SUBJECT: NuScale Power, LLC Supplemental Response to NRC Request for Additional Information No. 401 (eRAI No. 9447) on the NuScale Design Certification Application

NuScale Supplemental Response to NRC Request for Additional Information eRAI No. 9447

NRC Question No.: 03.11-19

Figure 3.7.3-2b: Bioshield Conceptual Design (Elevation View During Stacked Configuration)

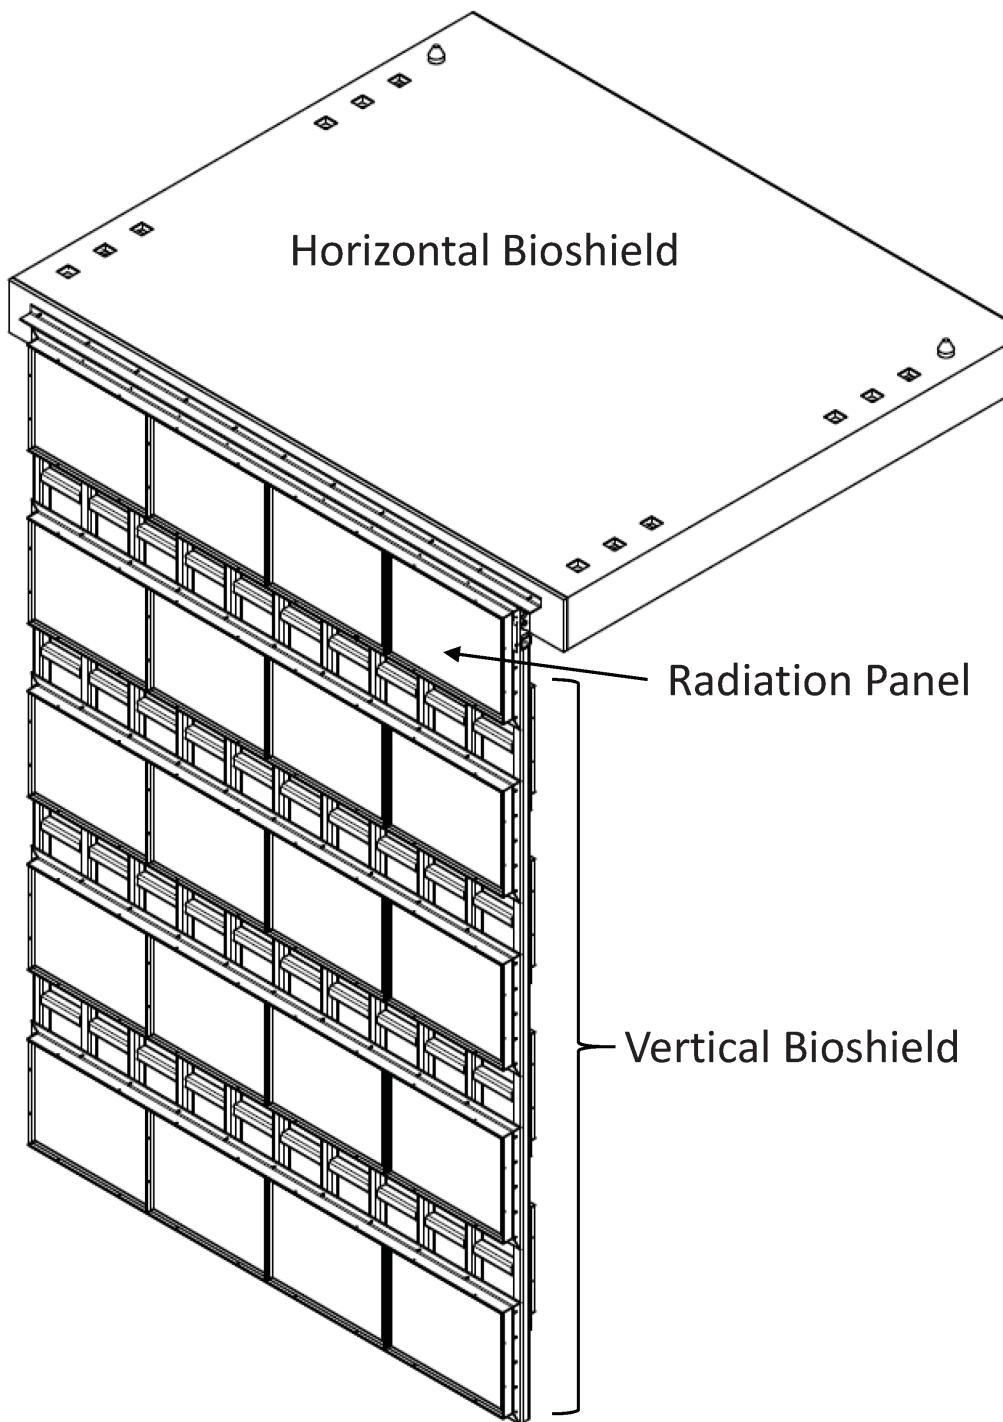
Add a stacked and unstacked bioshield drawing to the FSAR.

Add drawings to DCA of stacked and unstacked conditions with annotations

A stacked and unstacked configuration of the bioshield is added to the FSAR. FSAR Tier 2, Figure 3.7.3-2a shows an isometric view of the bioshield design in an unstacked configuration and Figure 3.7.3-2b shows an elevation view of the bioshield design in a stacked configuration.
